Instructions for upgrading the GROCO HC or HE toilets to an HF toilet

The evolution of GROCO's HC model toilet to HE and now HF has necessitated the addition, deletion, or modification of some parts. The changes have resulted in greatly improved toilet operation.

PARTS & ASSEMBLY

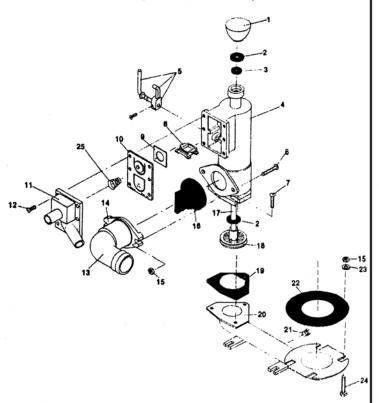
<u>Item 5: HF-20 Cam Assembly.</u> THe HF-20 combines the cam action required to open and close the toilet inlet with a more effective vacuum breaker, resulting in easier dry-bowl pumping and a more positive shut-off of inlet water when the valve handle is placed in 'DRY BOWL'.

<u>Item 8</u>: <u>HF-28 Bridge</u>. Provides support for items 9 and 10, thus preventing loss of pump suction.

<u>Item 10</u>: <u>HF-1 Gasket</u>. This injection-molded part replaces former neoprene gaskets with bronze weights. It provides greater accuracy and more positive flushing with the valve handle in the 'FLUSH' position.

Items 17, 18, HF-10 Piston/Ring Assembly and HF-21 Shaft. This new design provides more positive flushing and a positive seal against back-flow from the toilet discharge. The HF-21 shaft is required in order to restrict the pump stroke length to 7-1/4".

<u>Item 25</u>: <u>HF-26 Spring.</u> Assures that the HF-1 gasket is properly seated in the 'FLUSH' position, allowing the pump to prime itself.

<u>HT-49-A Joker Valve</u> (not shown). HC and HE models used HT-49-A to break the vacuum for dry-bowl pumping, but is not used on HF. The HF Upgrade Kit includes a plug to close off the HT-49-A.

HC and HE pump cylinders are no longer available. When you order a pump cylinder you will receive the HF-C cylinder with an adapter kit to fit it to your HC base.

Includes items 5, 8, 10 and 25 (drawing at right), and is intended to upgrade early. HF models to the current configuration. The kit will prevent unwanted bowl filling from the toilet inlet by providing a positive shut-off when the valve handle is placed in 'DRY-BOWL'. (See note below)

Includes HF Cam Kit items plus items 17 and 18, and is intended to upgrade HC and HE models to the current HF configuration. Also included is a new 'FLUSH' label and an HT-49-B plug to close off the HT-49-A vacuum breaker, which is no longer used. In addition to the improvements provided by the HF Cam Kit, the HF Upgrade Kit also prevents back-flow from the discharge side of the toilet.
